intel® Technical Advisory

TA-521-1

Intel® SDS2 Server Boards Assembled with Incorrect I/O Gasket

Incorrect I/O gasket:

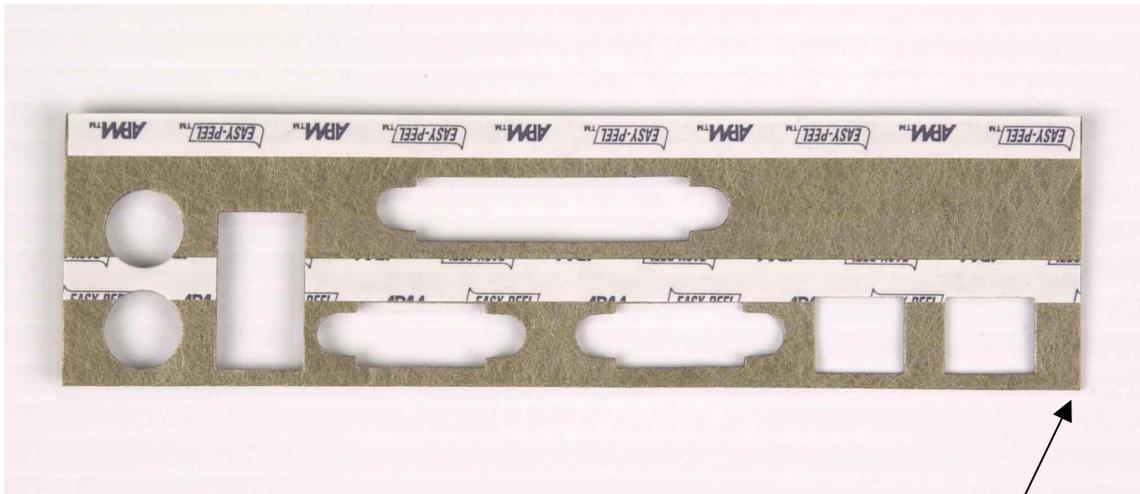
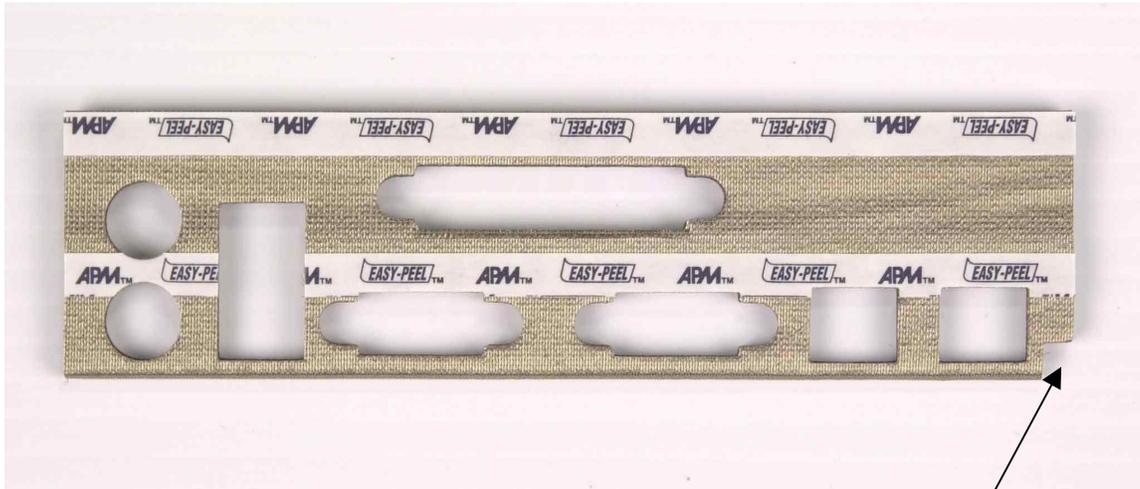
Approximately two thousand SDS2 server boxed boards were assembled with the incorrect I/O gasket. The incorrect I/O gasket does not have a cut out in the lower right corner for the system identification LED. The incorrect I/O gasket is also made with a thinner gasket material. Photographs of the incorrect I/O gasket and also the correct I/O gasket are shown:

No cut out for system identification LED

Cut out for system identification LED

The incorrect I/O gasket covers the system identification LED located on the SDS2 server board. Covering of the system identification LED is only an issue if the chassis being used with the SDS2 server board supports the system identification LED. The system identification LED is supported only by the rack-mount SKU of the SC5100 server chassis. The system identification LED is not supported by the pedestal SKUs of the SC5100 server chassis. The incorrect I/O gasket may be used with the pedestal SKUs of the SC5100 server chassis.

Customers who receive a SDS2 server boxed board with the incorrect I/O gasket may request a correct replacement I/O gasket. To obtain a replacement I/O gasket, contact Intel using your normal warranty process. Please indicate that you are calling regarding TA# 521-1, and have the following information when you call: the part number requested (A45305-003), and the serial number(s) for the board(s) needing the replacement part.
